Los Angeles River Ecosystem Restoration Feasibility Study

DRAFT – APPENDIX I
VALUE ENGINEERING STUDY

VALUE ENGINEERING STUDY SUMMARY REPORT

Final 29 April 2013
U.S. Army Engineer District, Los Angeles

Examples of terraces with existing and proposed conditions. Proposed condition 1 will maximize the vegetation on the terraces and proposed condition 2 allows for minimum vegetation.

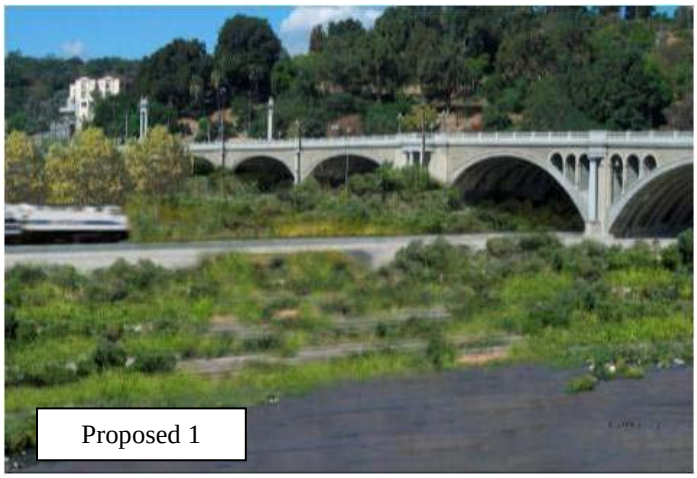
Terraces are incorporated throughout each reach to reduce the angularity of the trapezoidal channel, serve as a medium for vegetative restoration and provide public access points to the river. Terraces require demolition of the existing channel surface, change to the channel geometry and reconstruction through the use of concrete planters and surface walkways.

The proposed design is to reduce the scale of the terraces by 33% to achieve cost savings for the project.

Terraces compose a significant portion of the total project costs. Reduction in the scale of the terraces may be able to be achieved while maintaining high priority ecosystem restoration areas.
